**AMENDMENTS TO THE DRAWINGS:**

## **REMARKS**

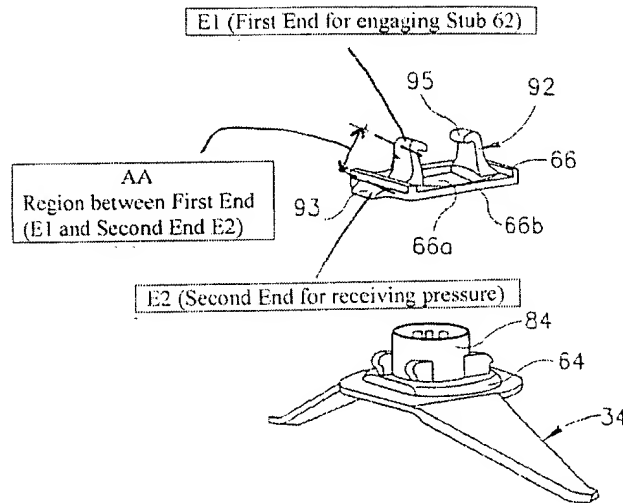
Please note that the previously amended “platforms” has been removed from claim 9 and replaced by “force receiving members.” It is respectfully asserted that in Figs. 5-7, element 93 is a “force receiving member”, and as such, is clearly shown in the drawings.

The “discontinuous with” recitation in claim 19 has been replaced with “separate from.” The requisite portion of the recitation, with reference to the drawings (element numbers added) reads, “said second portions 93 separate from and in communication with said first portions 95.” The “separation” in the claim language is based on elements 93 and 95 being at opposite ends of the flexible member 92, with the main body 94 located between elements 93 and 95.

DRAWING A  
Claims 9, 12, 16 and 19

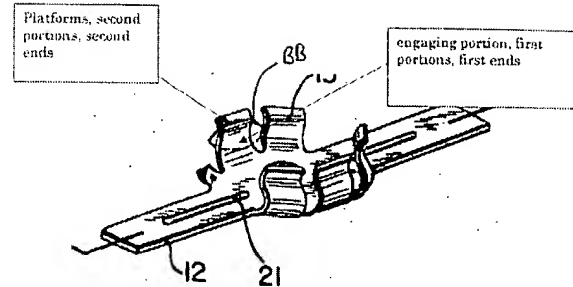
Independent claims 9 and 16 include recitations directed to a receiver formed by structures including a receiving portion and flexible members, with the flexible members including structures at one end for engaging the rotating member, and at the other or opposite end, for receiving pressure, for moving the engaging structure out of engagement with the rotating member. For example, as shown Drawing A (taken from the exploded view of Fig. 5 of the instant patent application) there is a receiving structure 84 with flexible members 92.

Independent claims 12 and 19 are similar to claims 9 and 16, in that they recite the two portions of the flexible members, with engaging structures at one end, and pressure receiving structures, at the other, or opposite, end. In claims 9, 12, 16 and 19, the structure of the flexible members that engages the rotating member, is different and separate from the structure that receives the pressure (for moving the rotational member engaging structure). For example, as shown in Drawing A, the flexible members 92 include structure 95 for engaging the rotating member at a first end (E1), this structure 95 at the first end (E1) being different and separate from the structure for receiving pressure 93 at the second end (E2), the structures 93, 95 separated from each other by the region AA.

Weber '413 is directed to a device where a series of spring clips 13, receives and retains a hub 14. These spring clips 13 engage and hold the blade 12, and serve as a point for pressure, when moving the spring clips 13 outward, to disengage the blade from the hub, at the same location, and, are the same structure. This singular location on the spring clips 13, is indicated by the dotted line oval BB of Drawing B, below.

FIG.6

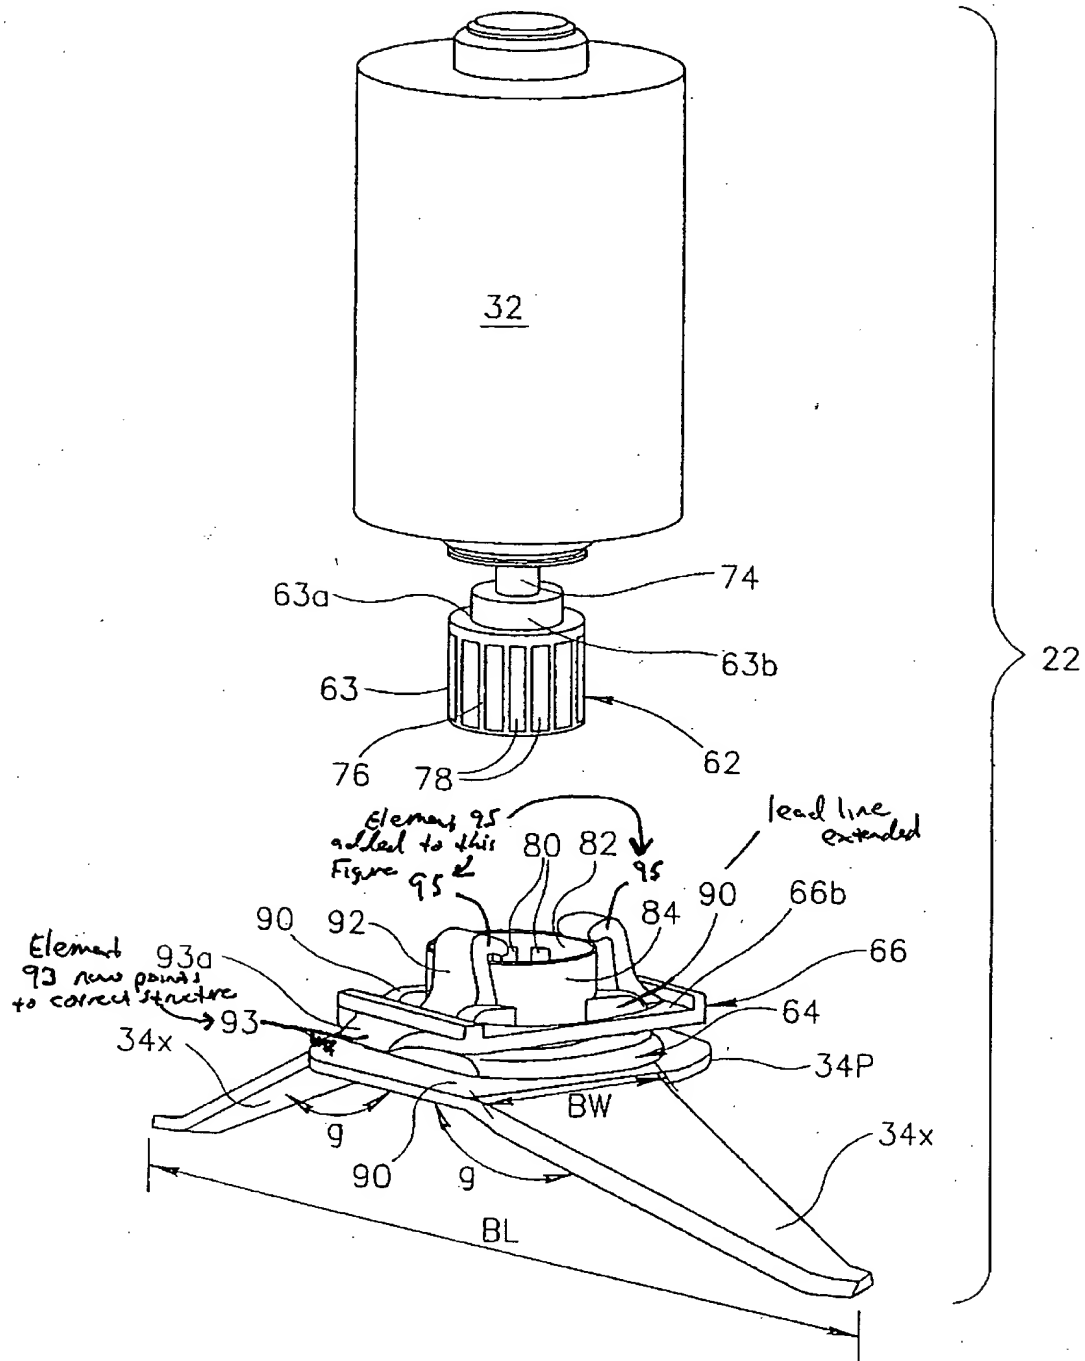
In Fig. 6, elements 90 and 93 have been provided with a corrected lead line, to point to the correct structure. Element 95 has been added.

FIG. 7

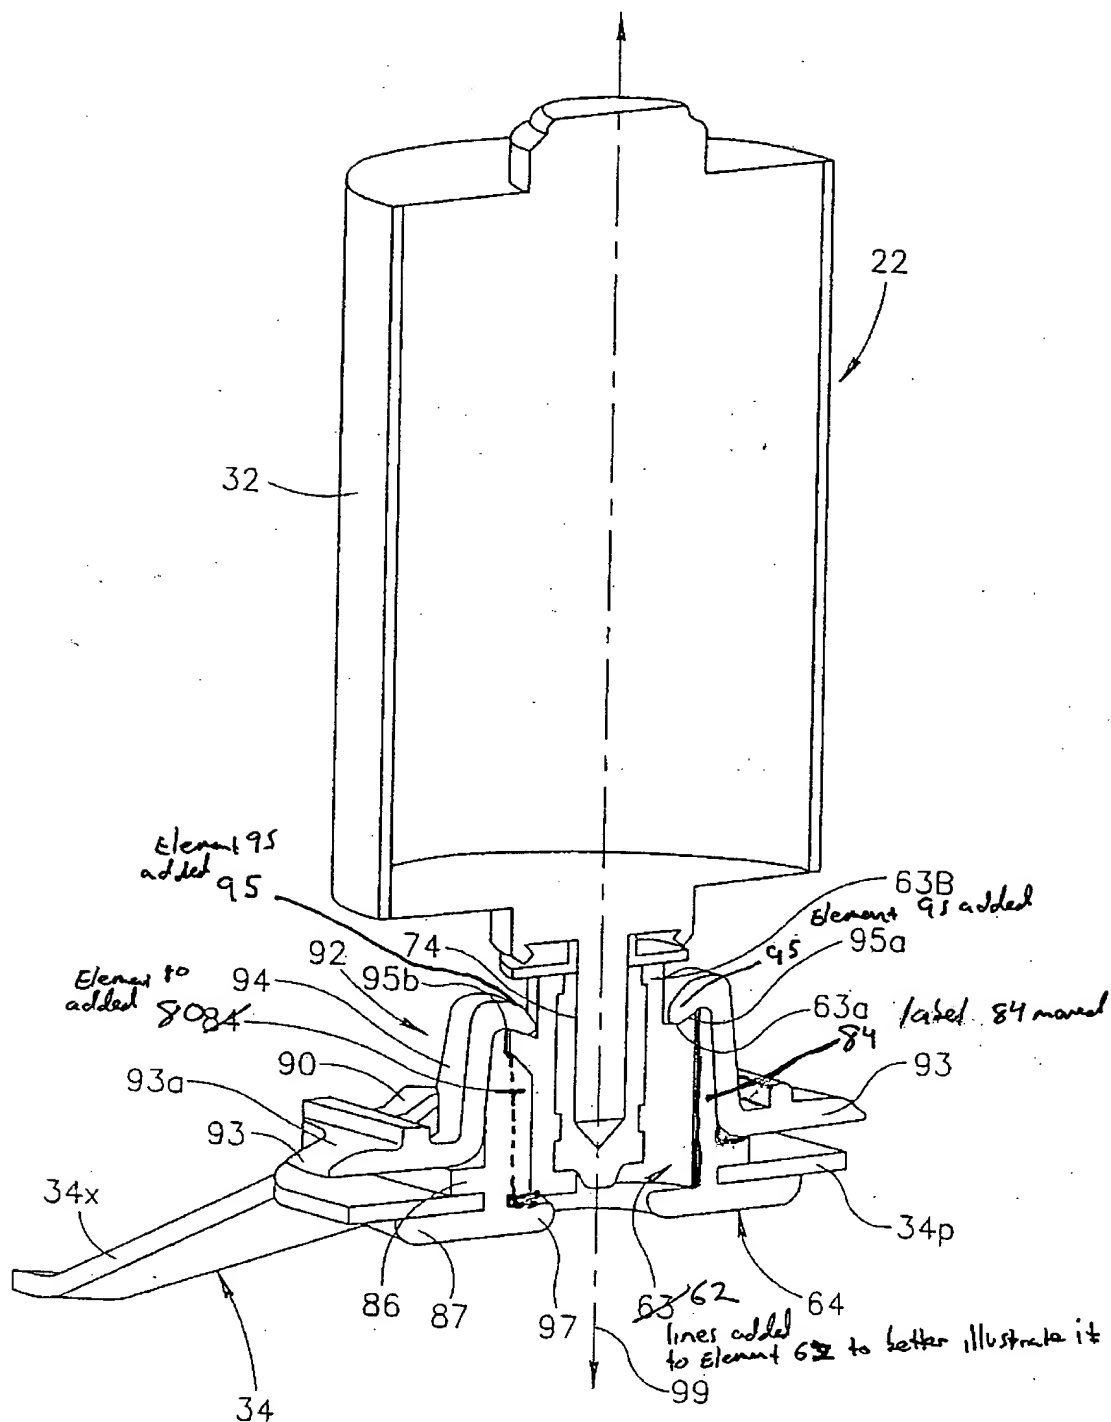
In Fig. 7, element 63 has been changed to 62 to reflect the stub accurately, and the stub 62 has been more accurately depicted. Element 80 has been added. The “84” has been moved with a lead line added to show element 84. Element 95 has been added.
